A Study of Issues: Concerning a Proposed Broadband Allocation within the 900 MHz Land Mobile Radio Band and Its Potential Impact on the Florida Power & Light Network

Dan Ericson
Senior Scientist
Harris Corporation

Figure 1, Existing and Proposed 900 MHz Band

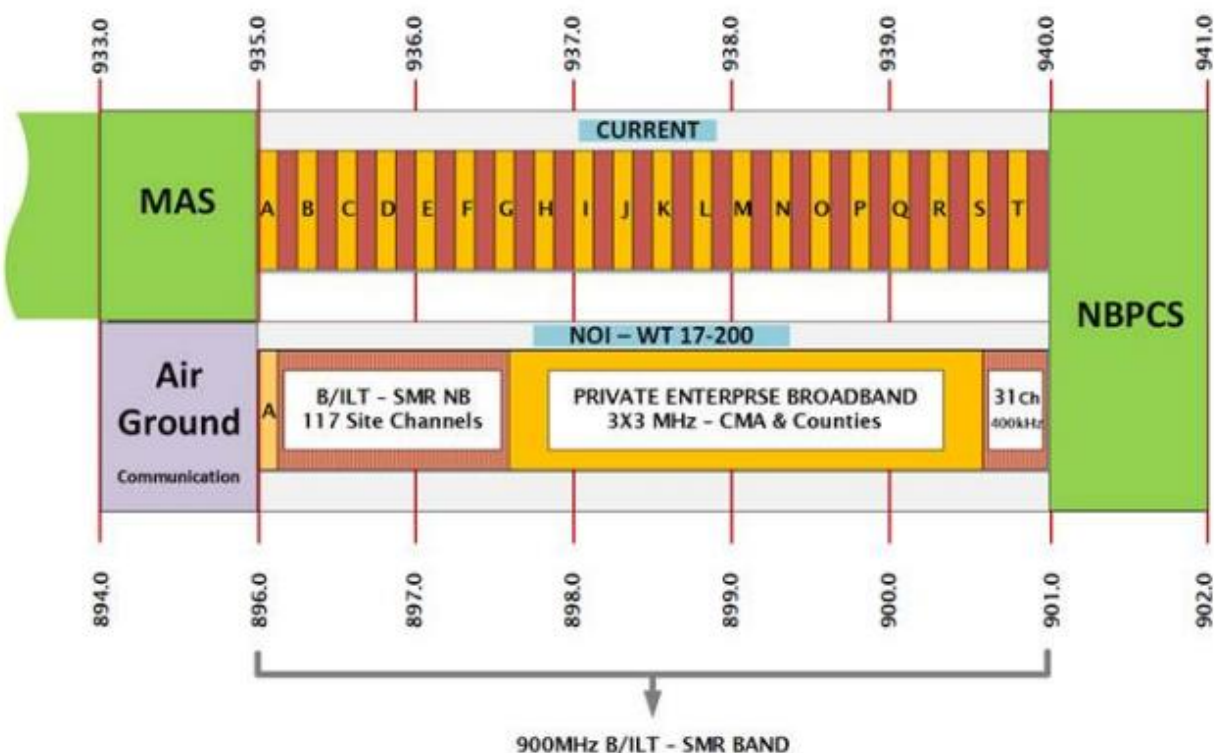
As currently proposed, the petition substantially reduces the available channels for LMR communications. Figure 1 illustrates the current and proposed frequency plan for the 900 MHz band. As shown in the current frequency plan, FPL licenses channels in the red segments (B/I/LT) of the spectrum that are interleaved with the orange lettered segments (SMR). The current rules allow for 199 frequency channels in the B/I/LT segments of which FPL has licenses for 156. The petition proposed

As proposed, the petition requires that SMR and B/I/LT licensees that currently have access to a total of 399 channels be limited to 148 channels. It further requires that licensees need to vacate any current licenses that are within the proposed broadband allocation while receiving comparable facilities within the LMR allocation. The current petition does not provide a timeframe or even a commitment for the

Figure 3, Receiver Sensitivity LOS Interference

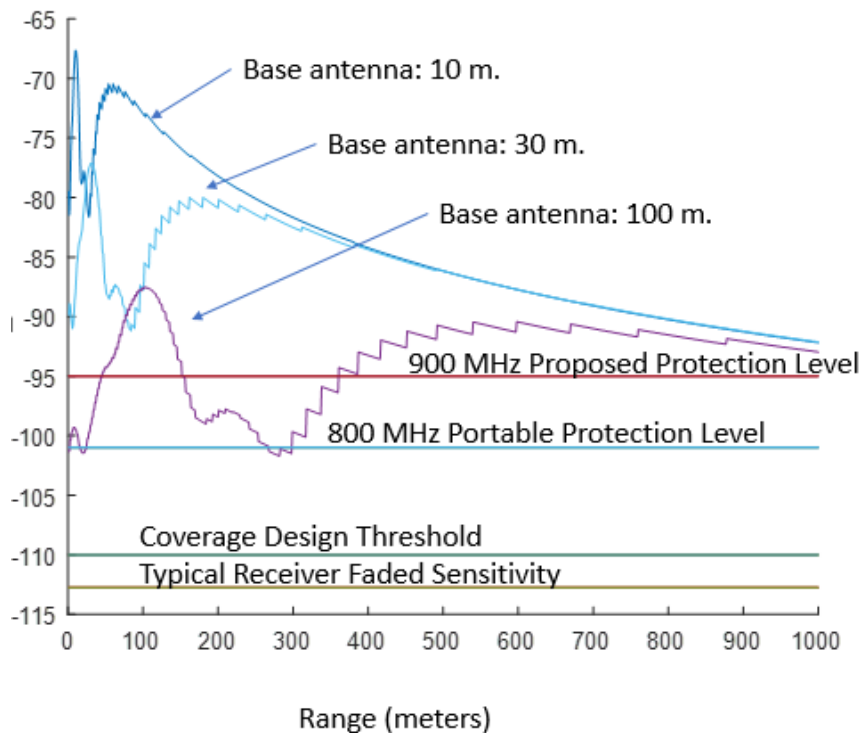
Proper interpretation of this graph is important. First, the graph illustrates the median signal strength of the desired LMR signal that must be incident at the LMR receiver for it to overcome the nearby LTE base station interference and present audio with a minimum DAQ of 3.4. Three scenarios are presented that

include PEBB base antennas at 10, 30, and 100 meters. Deployments at 30 meters are expected to be most common, but a range was simulated to demonstrate the range of interference levels that are associated with antenna height and the directivity of the base antenna. Second, the graph is based on a

Figure 3, Figure 4, and Figure 5 illustrate that substantially larger coverage holes around LTE sites can be expected by the proposed lesser protections. Therefore, rules that establish protection limitations at 800 MHz should be adopted for 900 MHz.

Figure 4, Receiver Sensitivity with Interference

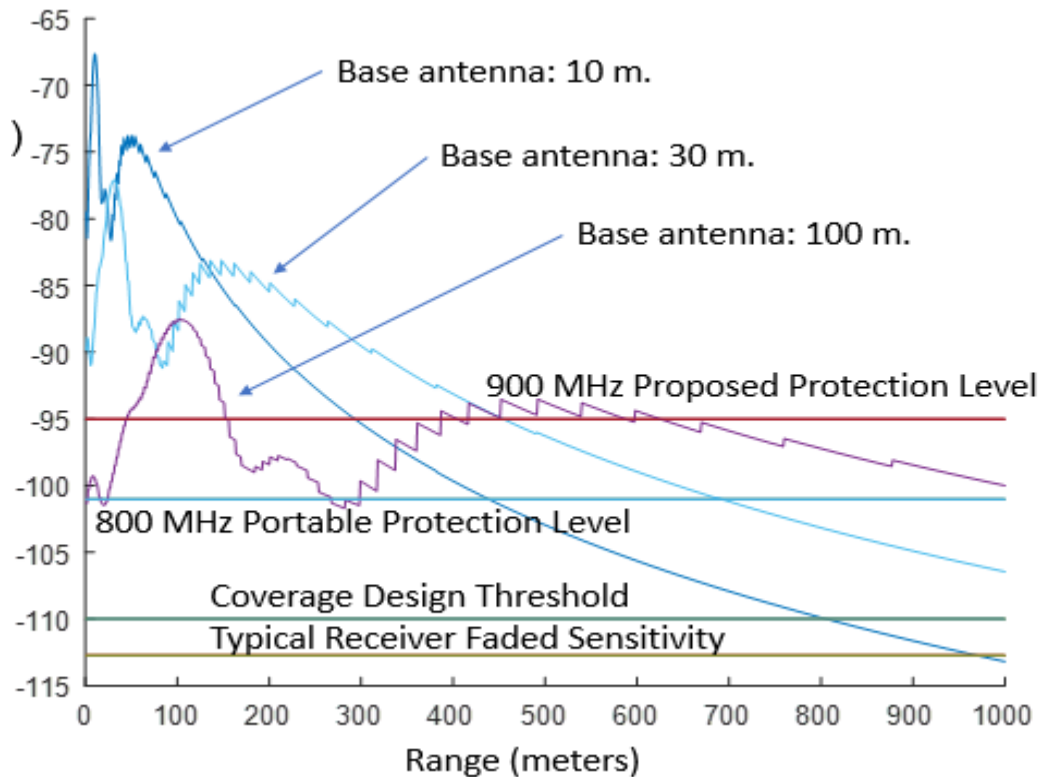
100-kHz analysis bandwidth. For the 16 LMR channels closest to the PEBB allocation, the required receiver signal may be as much as 5.3 dB higher because a 30-kHz analysis bandwidth is allowed.

The noise in the base station is treated as line of sight where free space is an appropriate model. This model would apply where the ground is relatively non-reflective, and obstructions do not exist in the field to act as barriers or reflectors. Based on this RF model, harmful interference above the protection level is continuous beyond 1 km from the broadband site.

Figure 5, Existing emission mask requirement adopted from 700 MHz

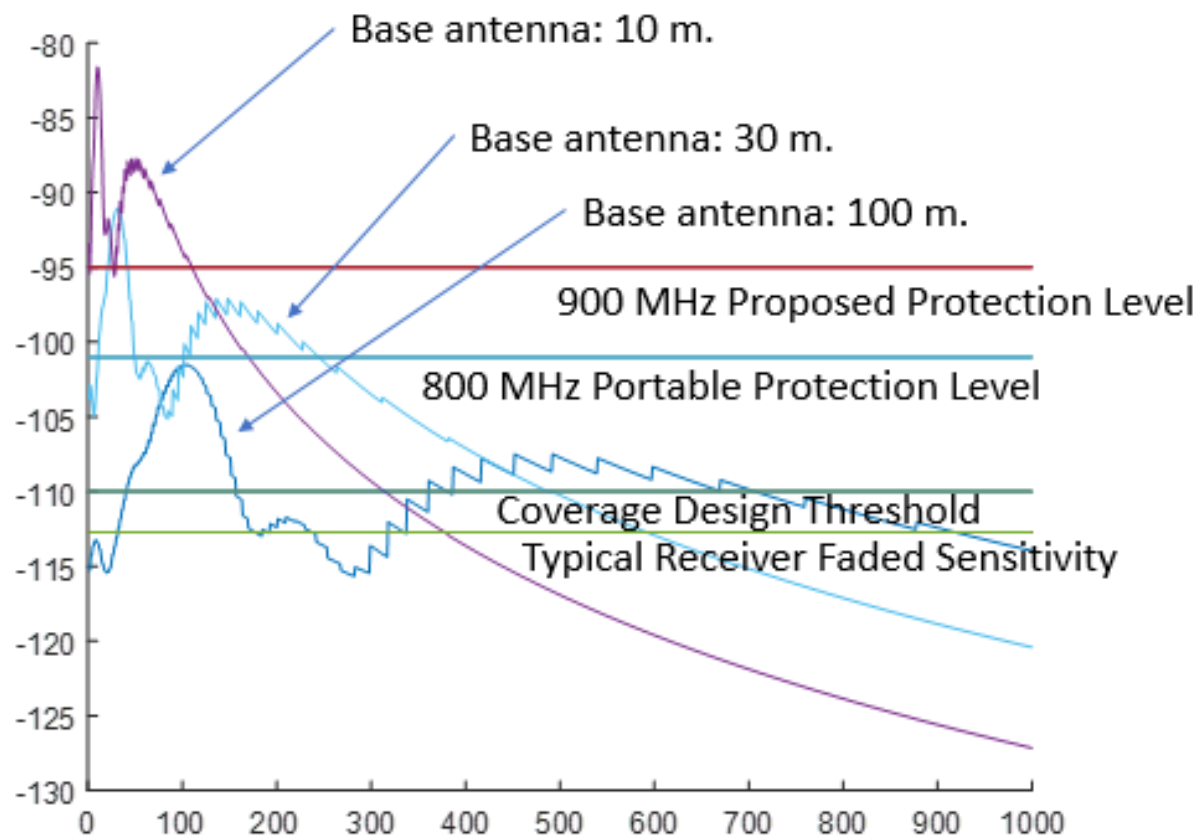
Figure 5 illustrates the simulated interference levels close to an LTE base station with the standards that have been accepted by both the FCC and 3GPP to protect the 700 MHz LMR band. With this adopted standard from the 700 MHz band, the typical 30-meter cell tower only exceeds protection threshold at much closer distances to the LTE site.

Based on the simulation results and existing rules accepted by both the FCC and 3GPP, Harris recommends that emission mask requirements for the LMR portion of the 900 MHz band should follow the same rule and require $76 + 10\log(P)$ per 6.25 kHz. The recommended $50 + 10\log(P)$ can be applied to other parts of the spectrum external to the 900 MHz LMR allocation.
